NP-12-0024
June 11, 2012

Subject: Exelon Nuclear Texas Holdings, LLC
Victoria County Station
Early Site Permit Application
Environmental Report – Response to ER RAI Letter No.8
Docket No. 52-042

References: (1) USNRC letter to Ms. Marilyn C. Kray, Environmental Request for Additional Information Letter No.8 Related to Aquatic and Terrestrial Ecology for Victoria County Station Early Site Permit Application, dated April 27, 2012

Figure 2.4.1-9 Existing Streams and Wetlands

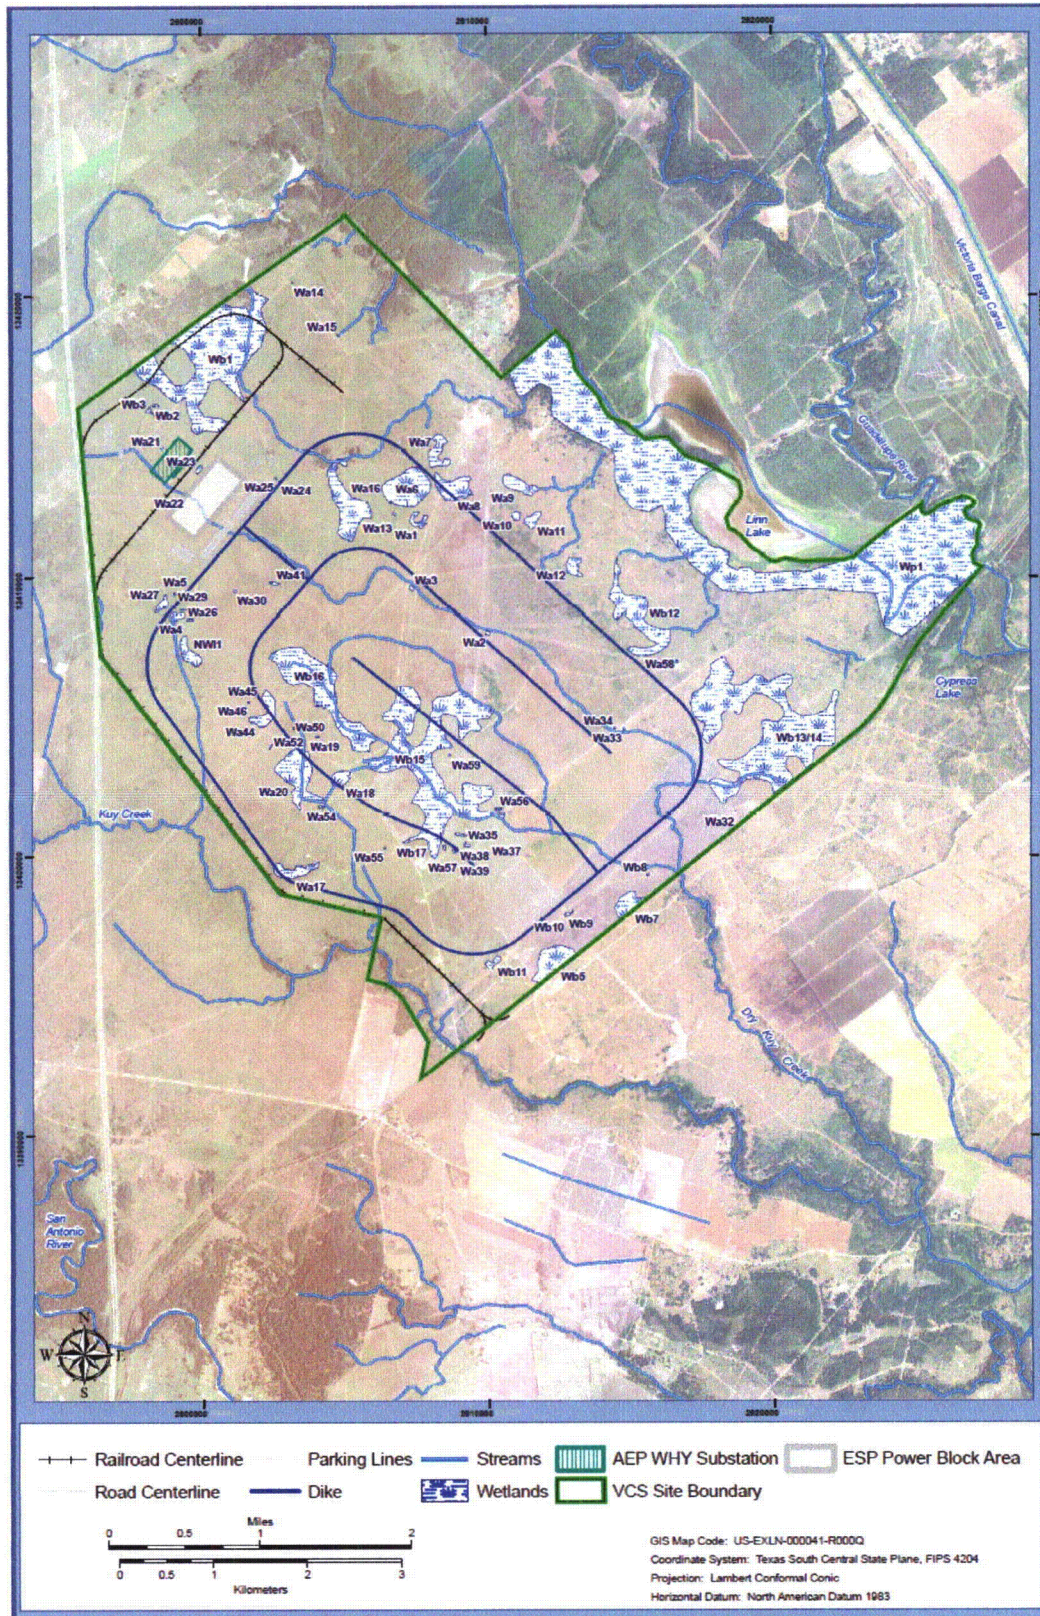
Changes to the following ESPA sections, tables, and figures will be incorporated in a future revision of the ESPA to reflect: 1) the addition of two wetlands identified during USACE PJD activities; 2) the revised construction disturbance footprint; and 3) updated potential wetland impact acreages:

SSAR Figure 2.4.1-9 will be revised as follows:
